TECHNICAL BULLETIN
Bell Helicopter **TEXTRON**

No. 412CF-04-75

MODEL AFFECTED: 412CF

SUBJECT: INTAKE SCREEN IMPROVEMENTS

Figure 1 (Sheet 1 of 2)
Screen Assembly
(Isometric view)

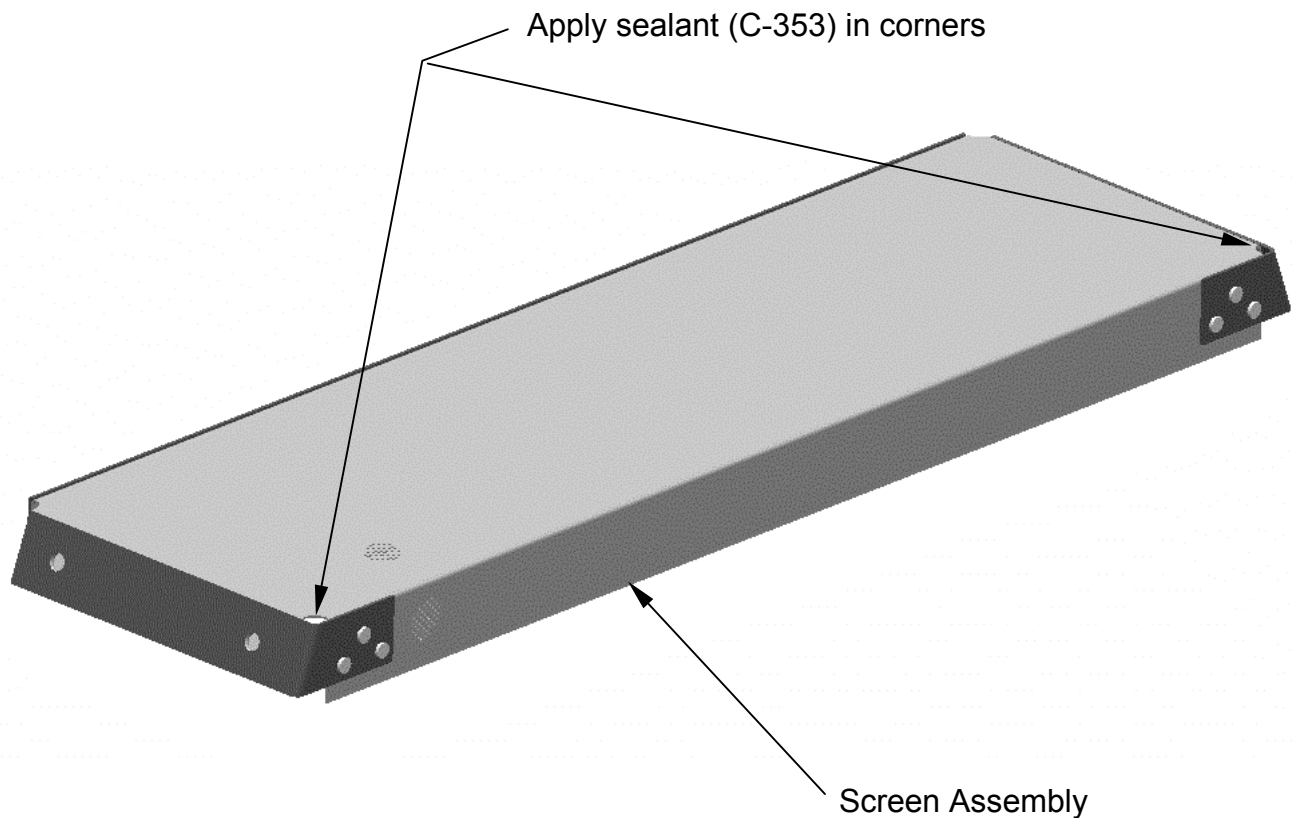
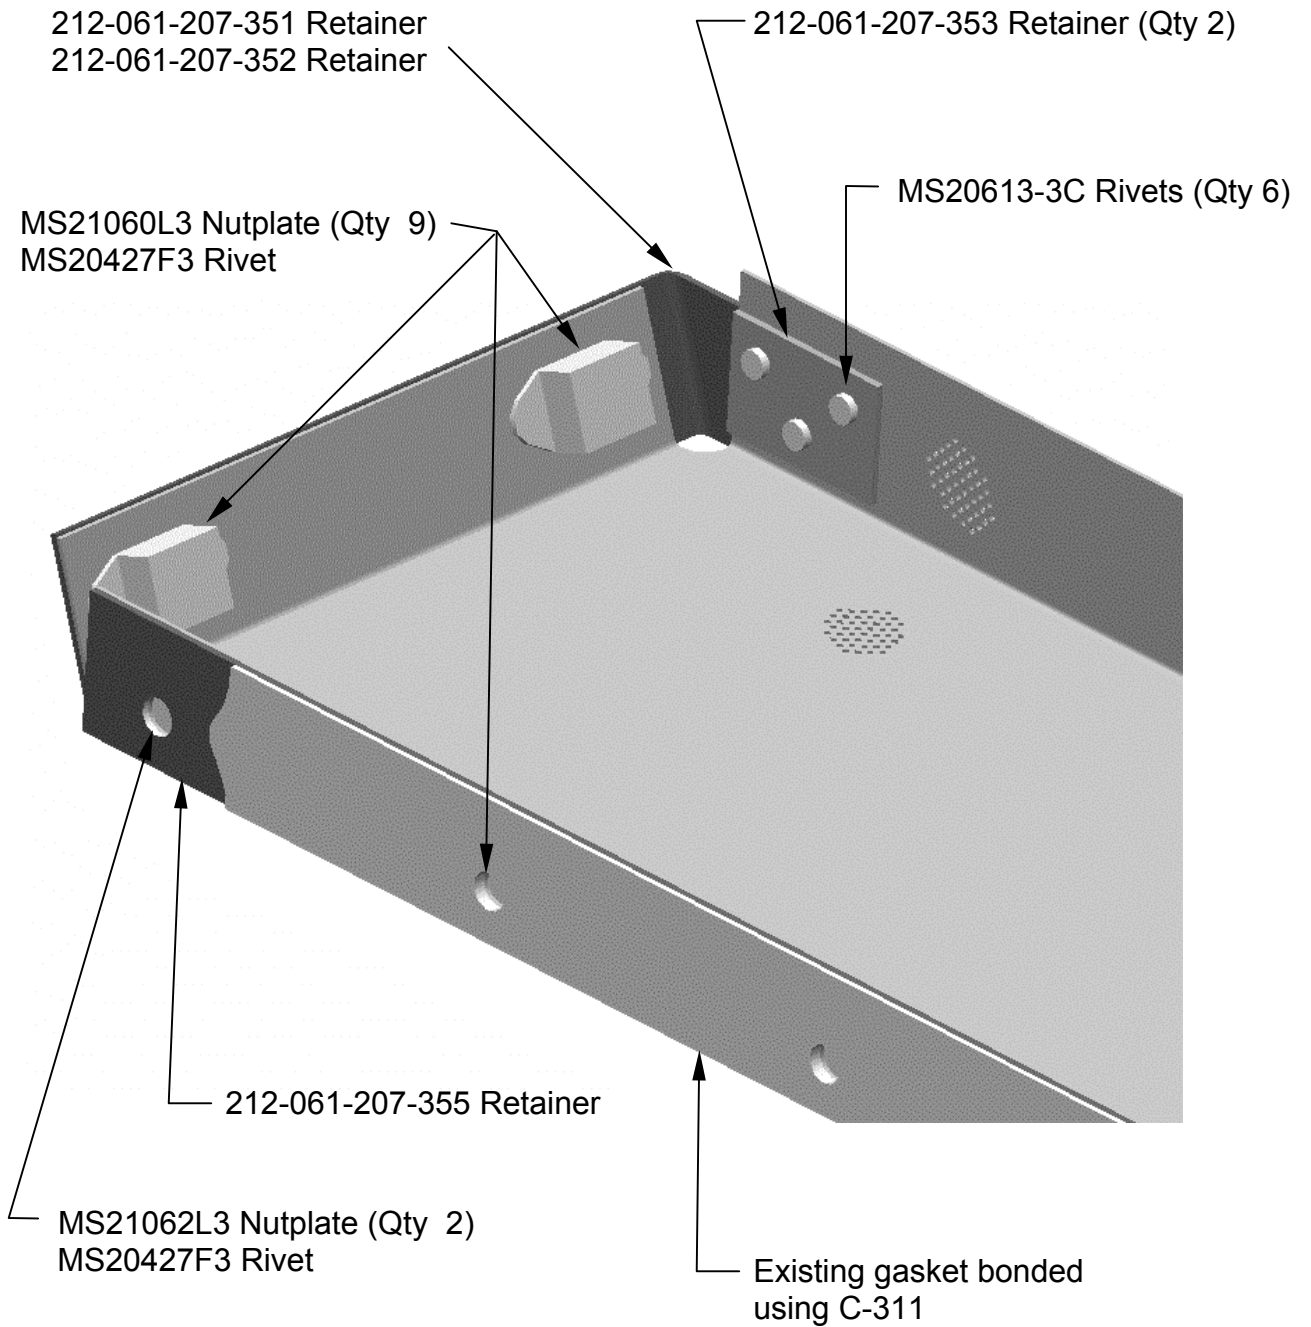
Bell Helicopter has been made aware of corrosion on small clips attached to engine intake screen assembly P/N 212-061-207-035, especially when operating over salt water. These clips were originally made of aluminum. This bulletin describes a procedure to replace the aluminum parts and existing nutplates of the screen with similar parts made of corrosion resistant steel. Alternatively, the new clips may be made locally or the complete screen replaced with the improved one (P/N 212-061-207-349).

4. Remove screens P/N 212-061-207-035 from LH and RH engine intakes.
5. Using a scraper, carefully remove gasket (P/N 212-061-207-061) and retain for reinstallation. Refer to Figure 1.

6. Remove and discard all existing retainers (P/N 212-061-207-097/-098/-099/105) and existing nutplates.
7. Position new retainer (P/N 212-061-207-355) and transfer rivet holes. Countersink nutplate rivet holes and install new retainer and new nutplates using rivets MS20427F3 of appropriate length.

8. Reinstall original gasket using adhesive (C-311).
9. Position new retainers (P/N 212-061-207-351/-352/-353) and transfer rivet holes. Countersink nutplate rivet holes and install new retainers using rivets MS20613-3C of appropriate length and new nutplates using rivets MS20427F3 of appropriate length.

10. Apply sealant (C-353) to fill any void or gap on the screen, specifically in bend relief holes. Allow to dry.
